To: Amy Moon, EFSEC; Ami Hafkemeyer, EFSEC
From: Dave Kobus, Scout Clean Energy
Cc: Tim McMahan, Stoel Rives; Pat Landess, Scout Clean Energy; Linnea Fossum, Tetra Tech; Troy Rahmig, Tetra Tech
Date: August 9, 2023
Subject: Horse Heaven Wind Farm Anticipated Project Modifications for Final Application for Site Certification

EXECUTIVE SUMMARY

1.0 LAYOUT MODIFICATIONS

Overview Map Turbine Layout Option 1

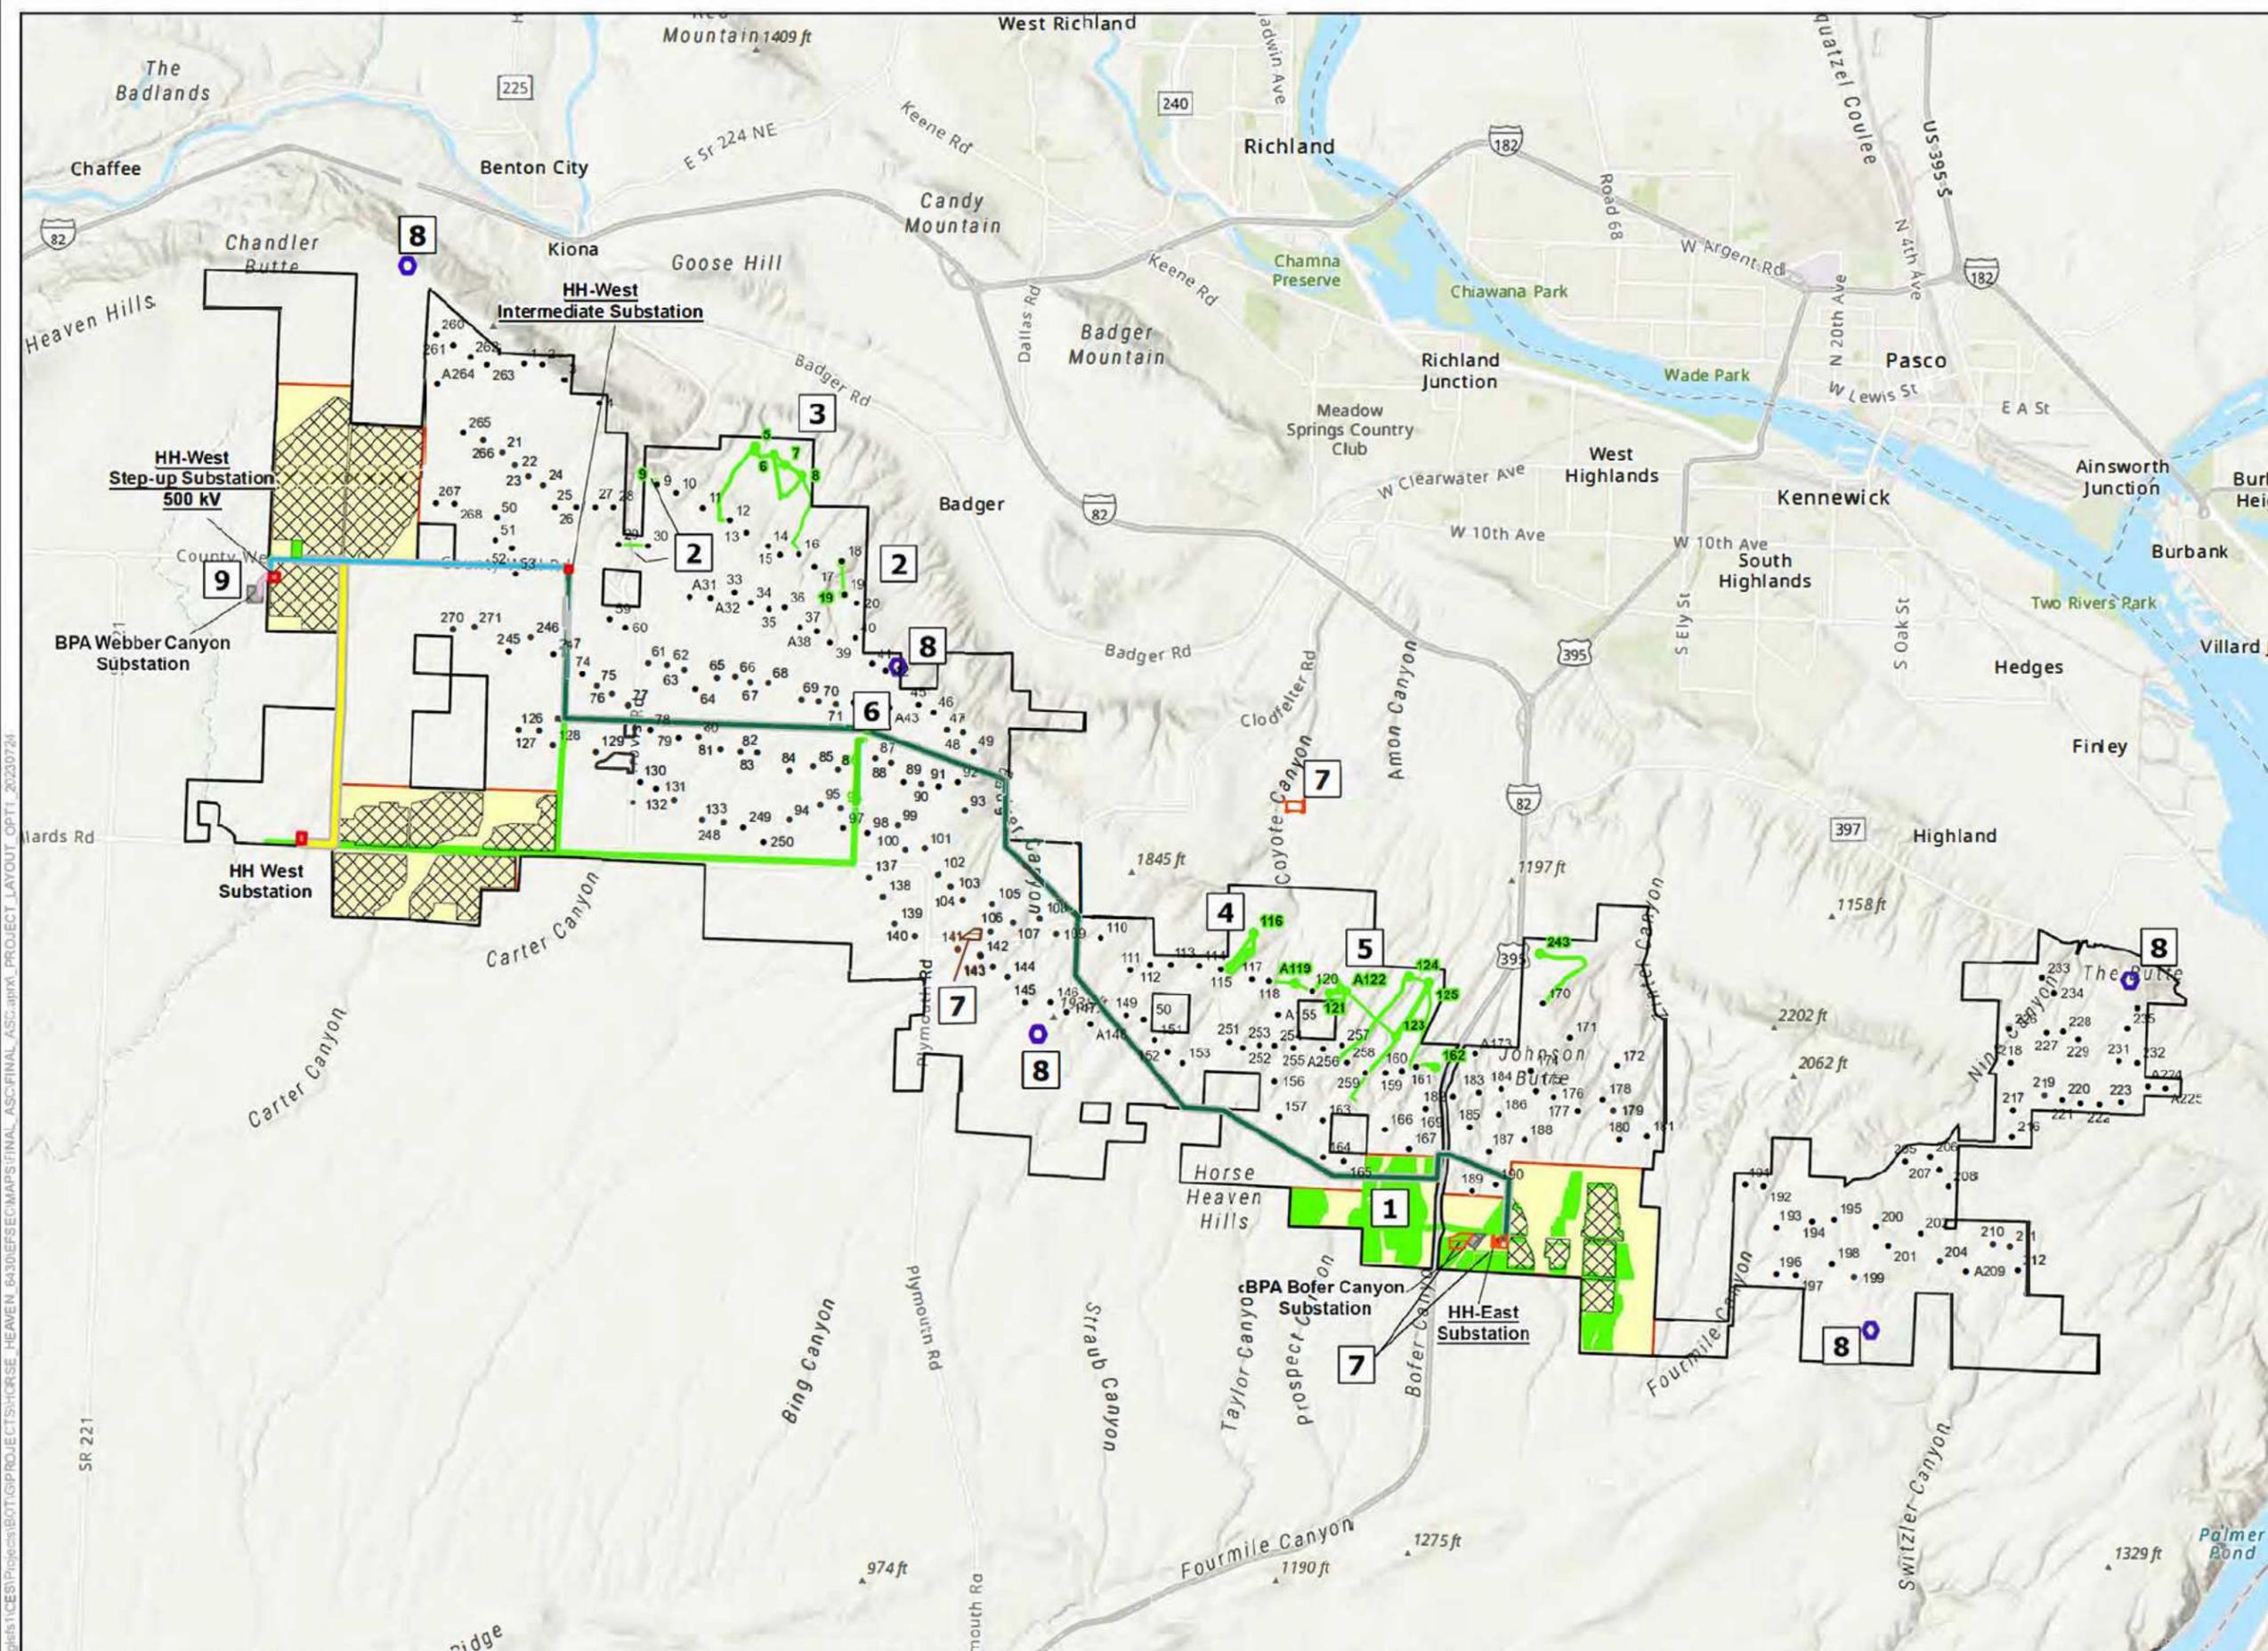
Planned modification: Remove all solar array infrastructure west of I-82; remove solar infrastructure within approximately 1 mile of I-82 on the east (see area '1' on attached overview map, Attachment 1). This modification will reduce the acreage of the fenced area for this array by approximately 1,398 acres, leaving a total of approximately 639 acres of fenced solar panels. This change will remove infrastructure that would have disturbed Priority Habitats, including rabbitbrush shrubland habitat, in the portion of this array originally proposed west of I-82. Note that temporary disturbance to Priority Habitat areas east of I-82, including temporary laydown areas, will still occur, but there will be no permanent impacts to Priority Habitats in the East Solar Area with this change.

Planned modification: Collector lines and Turbines have been moved farther away from Webber and Sheep canyons (see area '2' on attached overview map). Turbines 8, 18, and 19 were shifted as much as possible from canyon rims while remaining within the bounds of the Department of Defense Mitigation Agreement; see Table 1 for new turbine coordinates. In addition, collector lines originally planned to span the canyons have

Planned modification: Remove Turbines 5, 6, 7, and 8 from the proposed layout (see area '3' on attached overview map; see Table 1 for coordinates of Turbines removed from the layout).

Planned modification: Remove Turbine 116 from the proposed layout (see area '4' on attached overview map; see Table 1 for Turbine coordinates).

Planned modification: Remove Turbine's 119, 121,122, 123, 124, 125, 162 & 243 (see area '5' on attached overview map; see Table 1 for Turbine coordinates) from the proposed layout.

Planned modification: Remove primary intermediate substation and associated 230-kV and 500-kV transmission line infrastructure; remove step-up substation on Sellards Road (see area '6' on attached overview map).

Planned modification: Add locations for Phase 1 and Phase 2 construction laydown; add interim Turbine component laydown area (see area '7' on attached overview map).

Facility Infrastructure Comparison Turbine Layout Option 1 Map 4 of 11

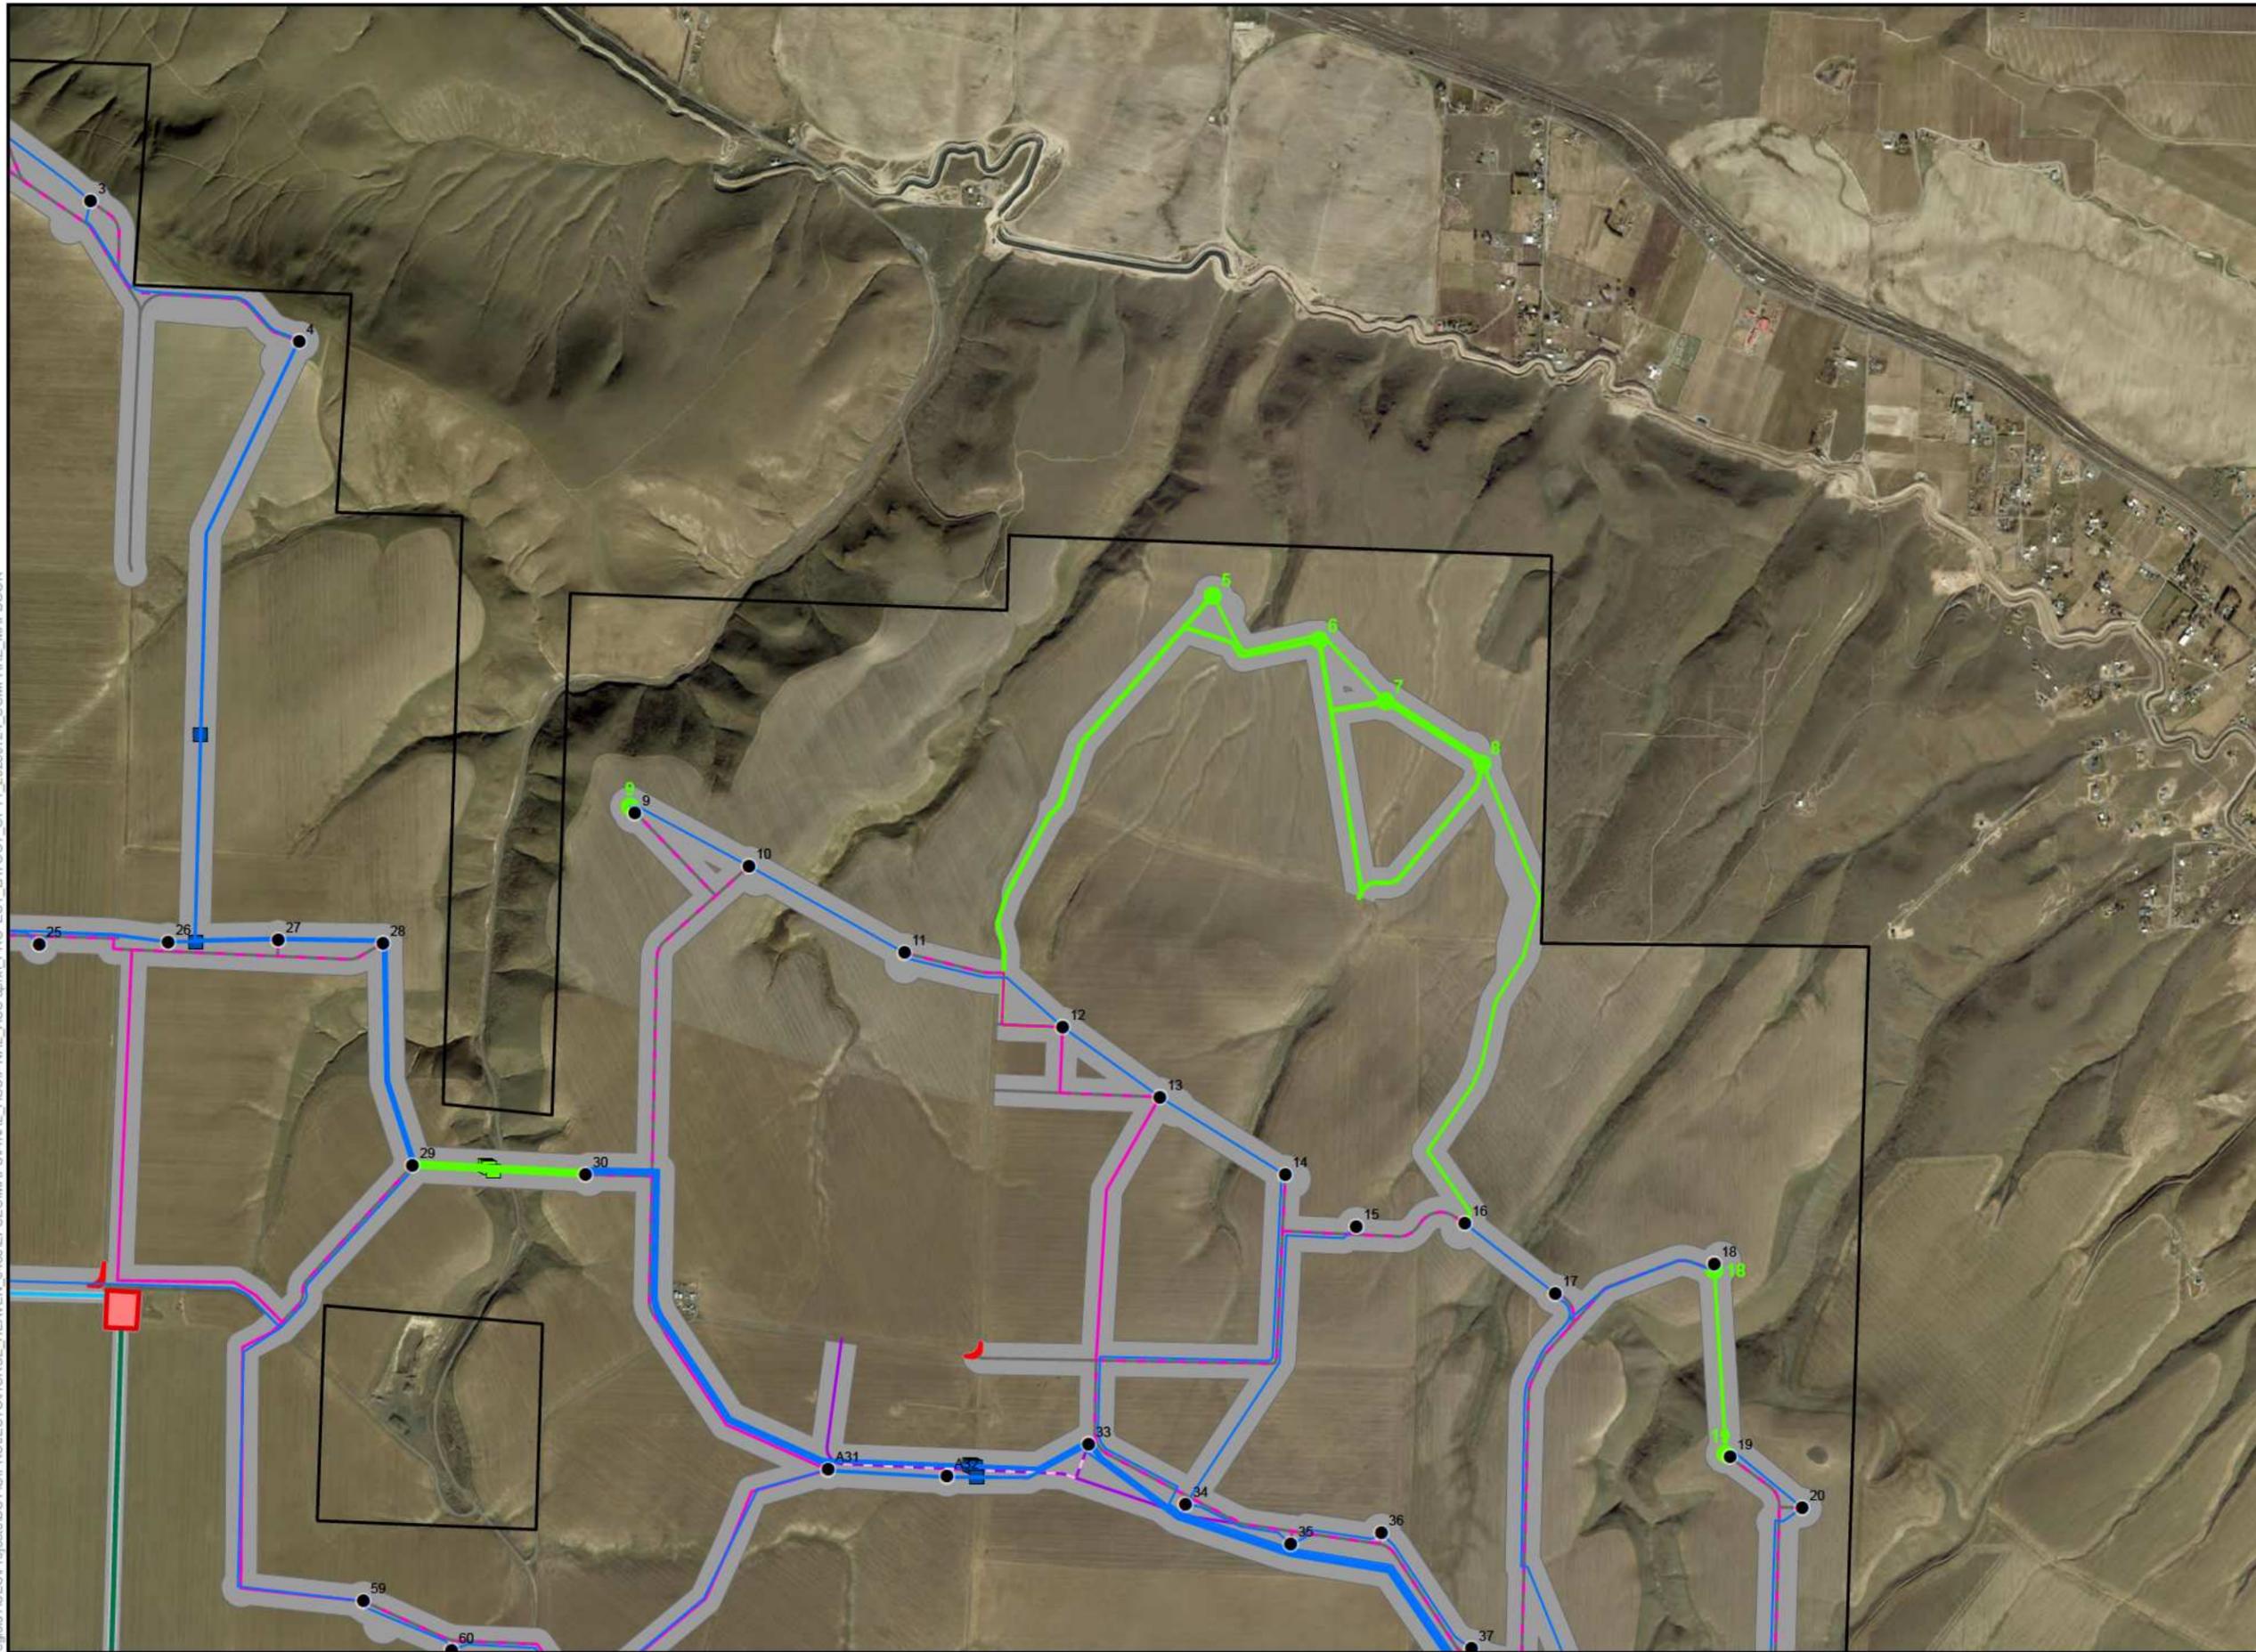
Planned modification: Extend the County Well Road 500-kV transmission line route to begin at the Intermediate Substation (p. 4 of Infrastructure Comparison mapbook, Attachment 1) to BPA’s planned new Webber Canyon substation. Although the line will now extend slightly further to the south and west to reach BPA’s planned new Webber Canyon substation location, immediately west of the Project site boundary, the majority of approx. 4 miles is being upgraded from 230 kV to 500 kV. Modify HH-West Project Substation and battery energy storage location to be closer to the new BPA substation but within the previously surveyed

Gould Well Location

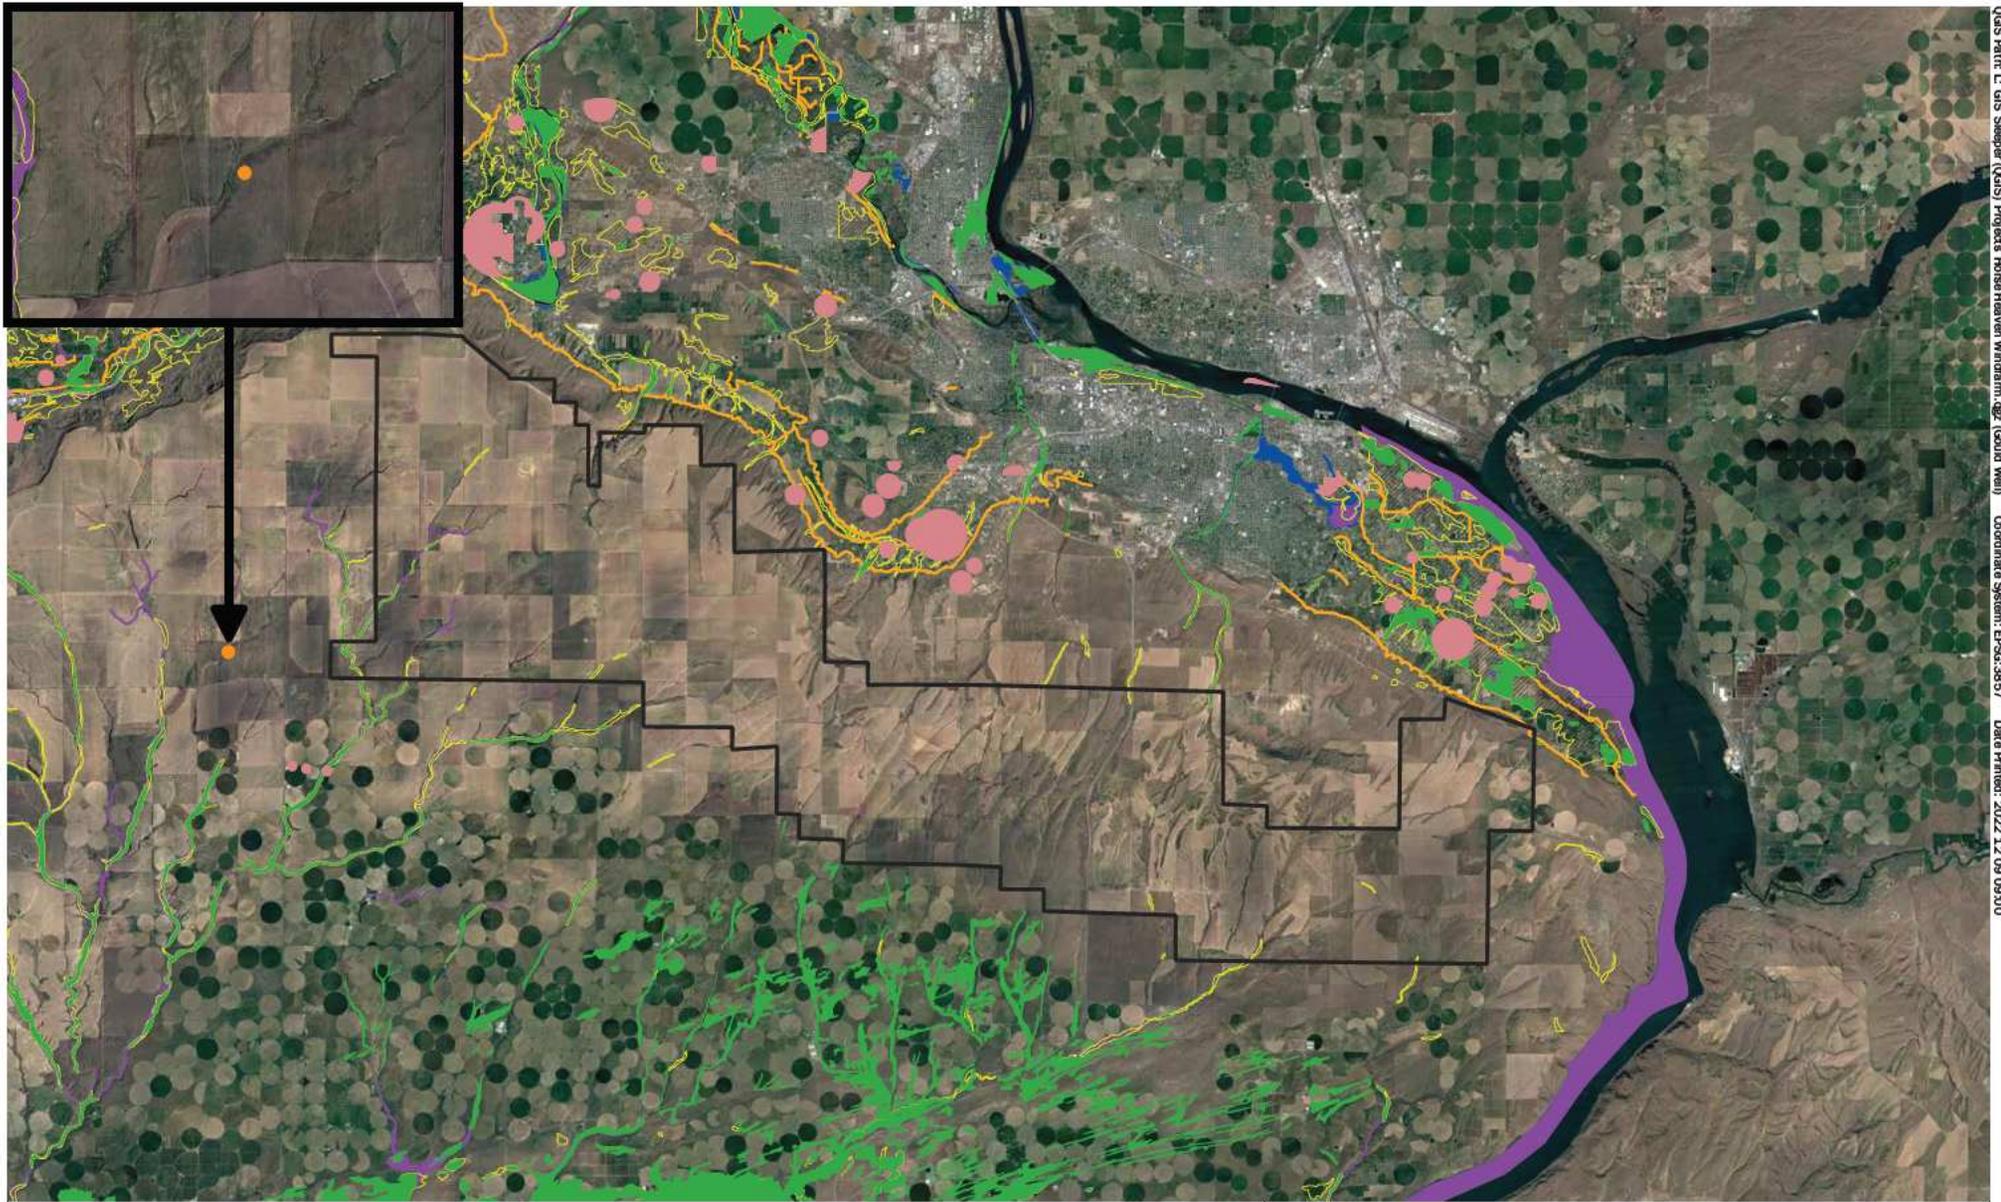
Planned modification: Scout is currently working with DNR to assess the potential for a lease agreement that would allow for use of a portion of DNR's existing water right associated with the Gould Well to be used during construction and operation of the Project. The Gould Well is located approximately 2 miles west of the Project lease boundary; see map in Attachment 3. The lease agreement, payment, and any necessary well improvements would be handled through a SEPA process to be conducted by DNR as a separate action
